ADDENDUM 1
WILLIAMSON COUNTY SCHOOLS
RFB #1220
College Grove Elementary School Wastewater Improvement
Tuesday, October 20, 2020

**WILLIAMSON COUNTY SCHOOLS
IMPROVEMENTS TO THE WASTEWATER TREATMENT FACILITIES
AT COLLEGE GROVE ELEMENTARY SCHOOL
WCS-RFB # 1220
(WMS #19162)**

ADDENDUM NO. 1 TO THE CONTRACT DOCUMENTS

CONCRETE PAVING

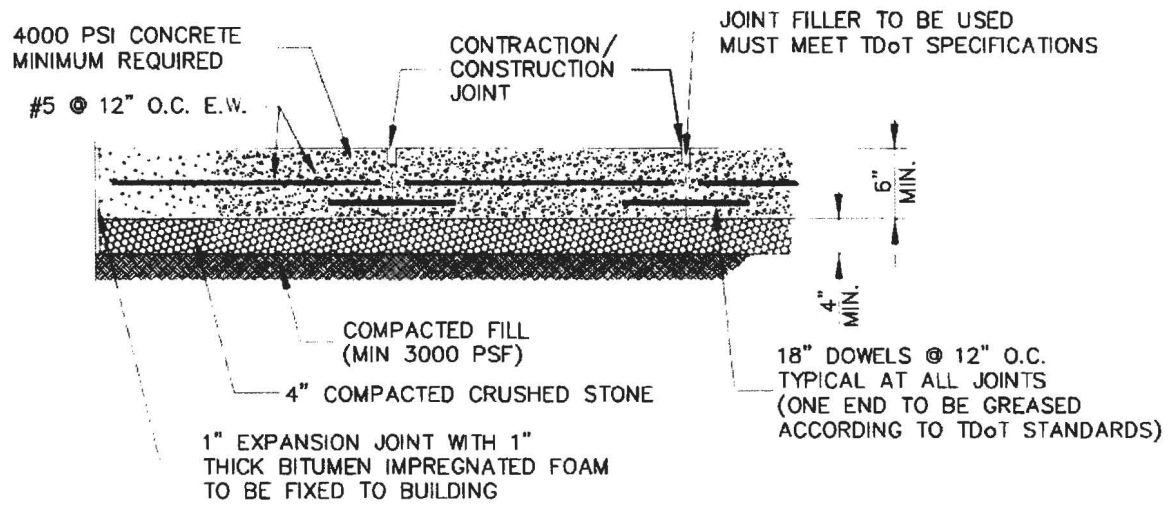
2. SHEET G-6

Replace the “TYPICAL ASPHALT ROADWAY SECTION” with the attached concrete paving detail.

NOTE: ALL CONCRETE PAVING SHALL BE BROOM FINISHED

NOTE: A EXPANSION JOINT IS TO BE
LOCATED AT ALL JUNCTIONS OF CONCRETE
PAVING AND ASHPALT PAVING
